Washington Co. Bridge BRO-B110(9)  
Project Job #13-3281

**ADDENDUM NO. 2**

**FOR:** Washington County Bridge No. 06100321  
BRO – B110(9) over Furnace Creek

**Attachments:** Revised Sheet C3, C4, C6, C7, C12, S18, S19 and Bid Form

**TYPICAL WATER GATE DETAIL**

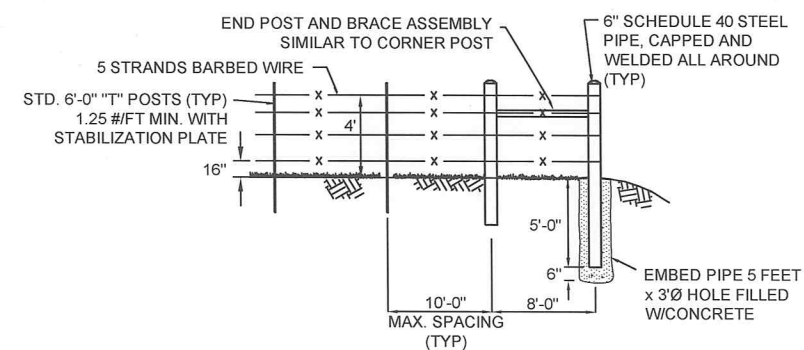
- Sheet C3 Water Gate Detail has changed to eliminate the pile in the creek. A note was also added stating if rock was encountered, prebore is considered incidental to the Watergate bid item cost.
- Sheet S19 has been changed to a MoDOT accepted crashworthy end terminal, therefore effecting the following pages:
  - C6
  - C7
  - C12
- Sheet S18 shows the additional guardrail required and C4 reflects the changed quantity of "Type A Guard Rail"
- Bid Form has been revised to show the change in Type A Guard Rail

| Date     | Revision/Issue | Details  |
|----------|----------------|--|
| 11-17-14 | 1              | REVISE WATER GATE DETAILS AND CONNECTIONS PER COMMENTS |

NOTE: IF ROCK IS ENCOUNTERED, PREBORE IS CONSIDERED INCIDENTAL TO THE WATERGATE BID ITEM COST.

TYPE "A" GUARDRAIL

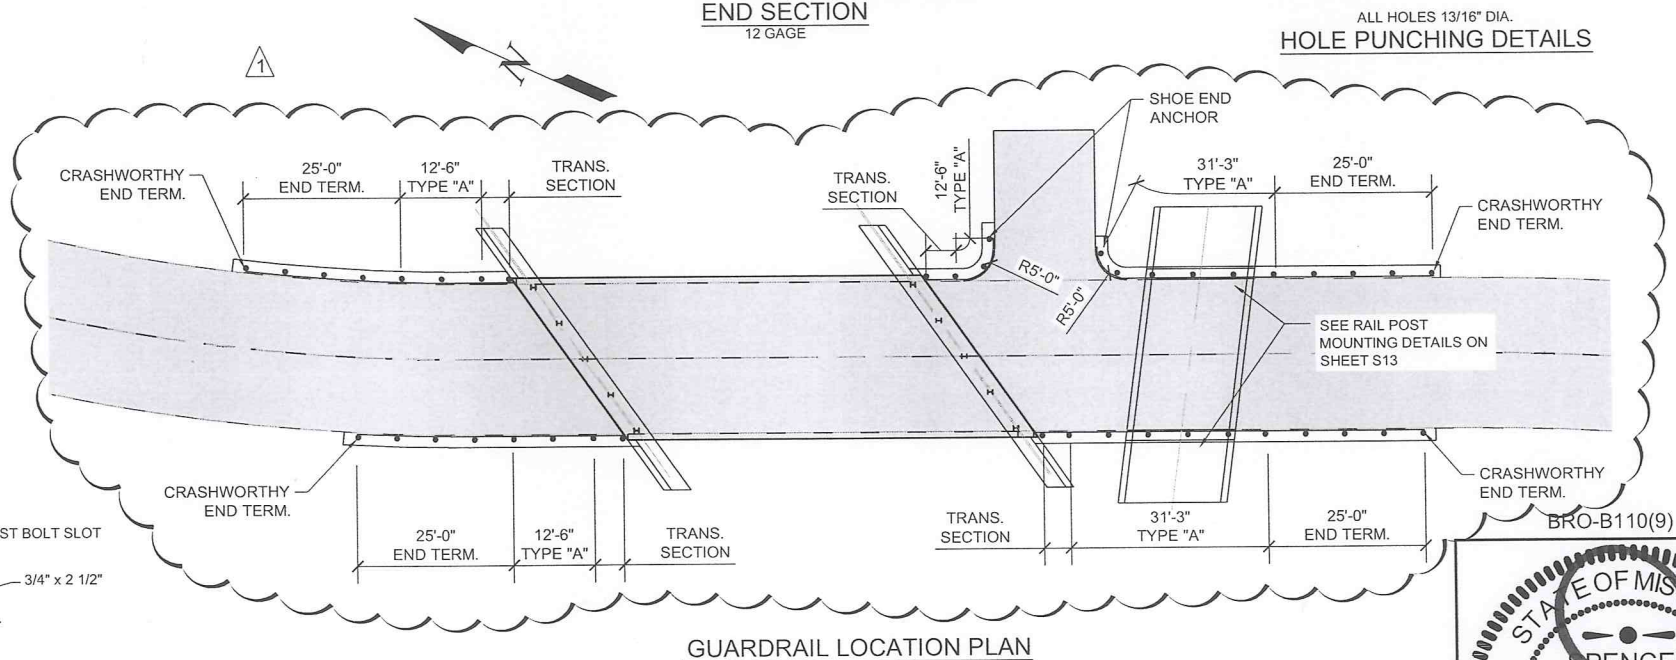
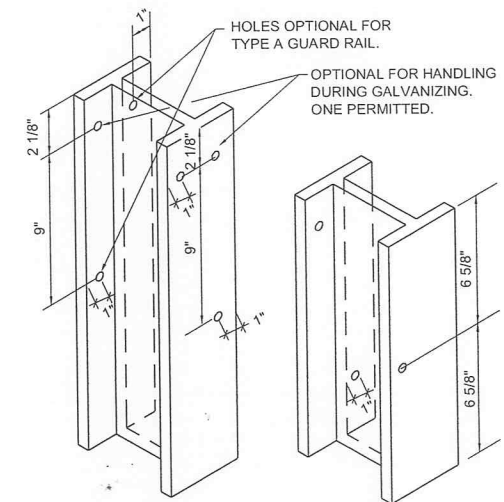
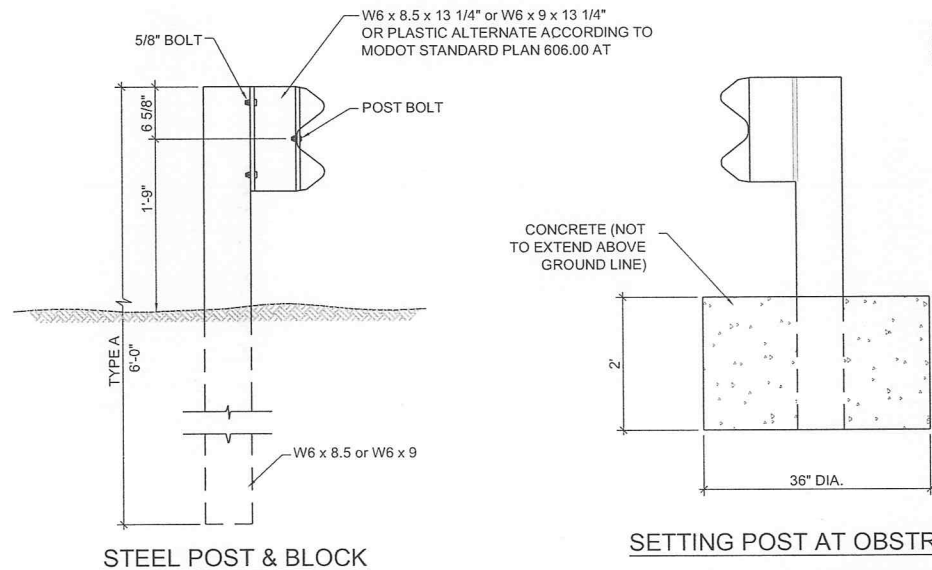
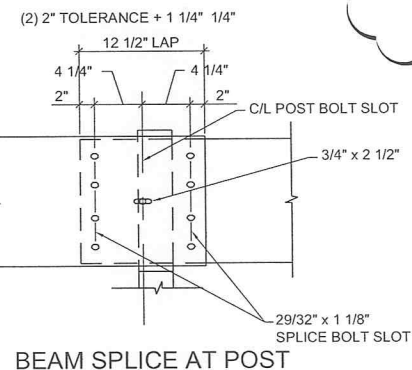
| No. | Revision/Issue                  | Date       |
|-----|---------------------------------|------------|
| 1   | REVISED GUARD RAIL PER COMMENTS | 11-17-2014 |

FURNACE CREEK ROAD BRIDGE #06100321  
WASHINGTON COUNTY, MISSOURI  
CRASHWORTHY END TERMINAL

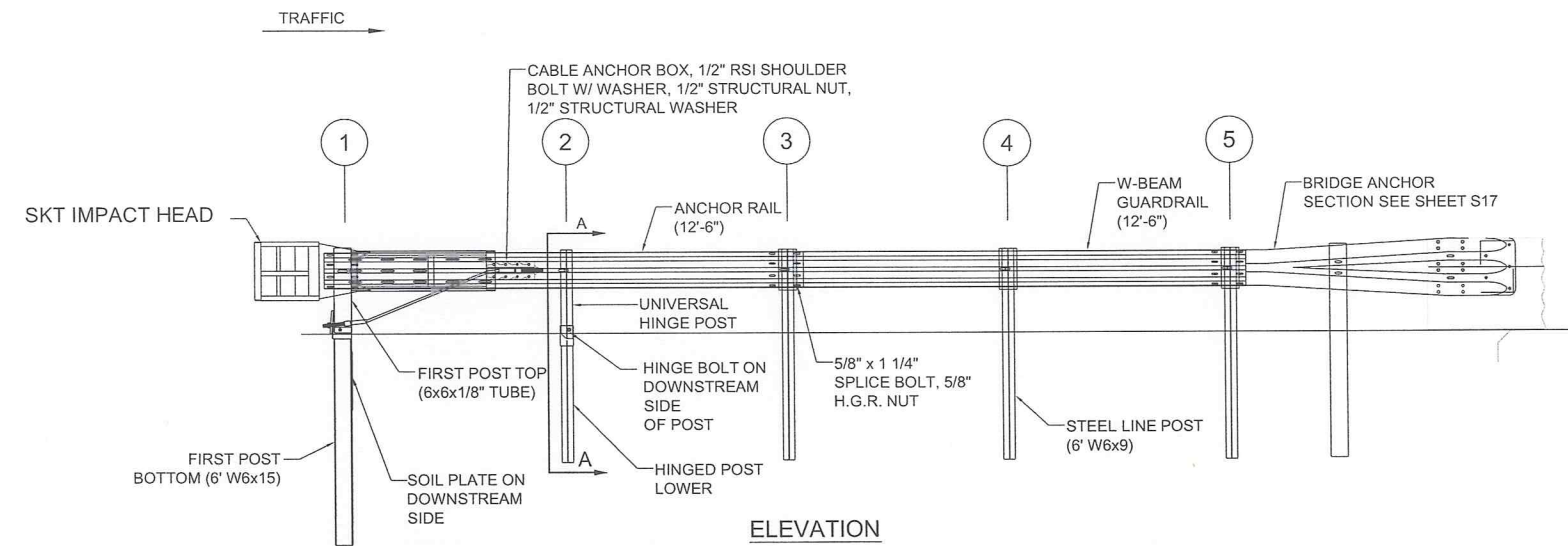
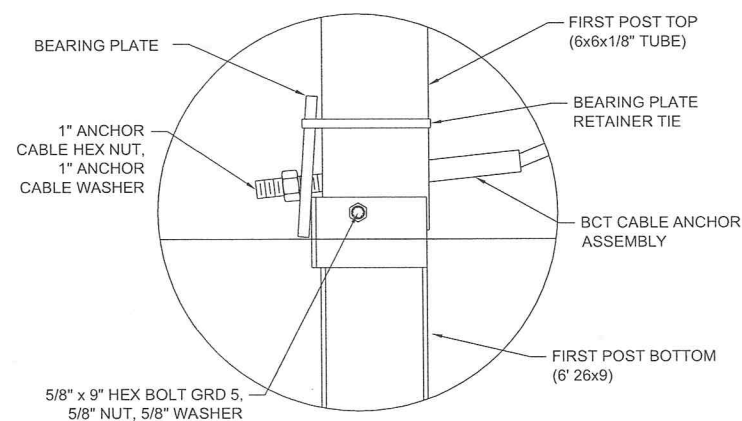
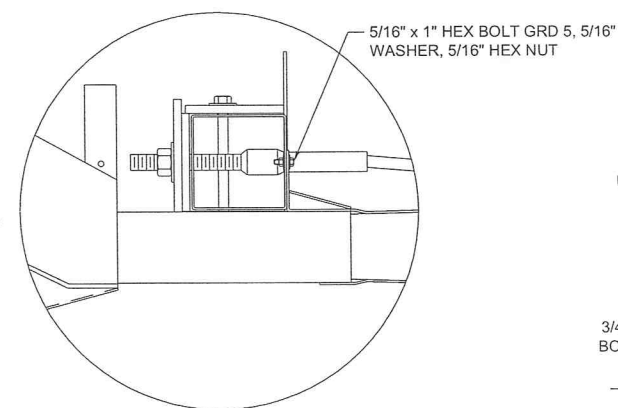
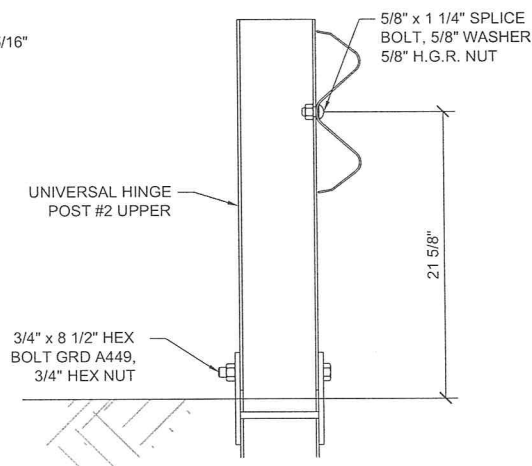
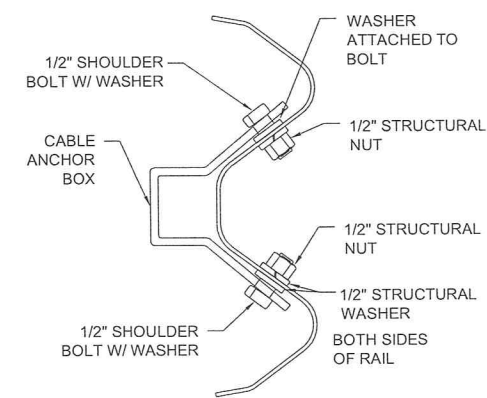
| No. | Revision/Issue                  | Date       |
|-----|---------------------------------|------------|
| 1   | REVISED GUARD RAIL PER COMMENTS | 11-17-2014 |
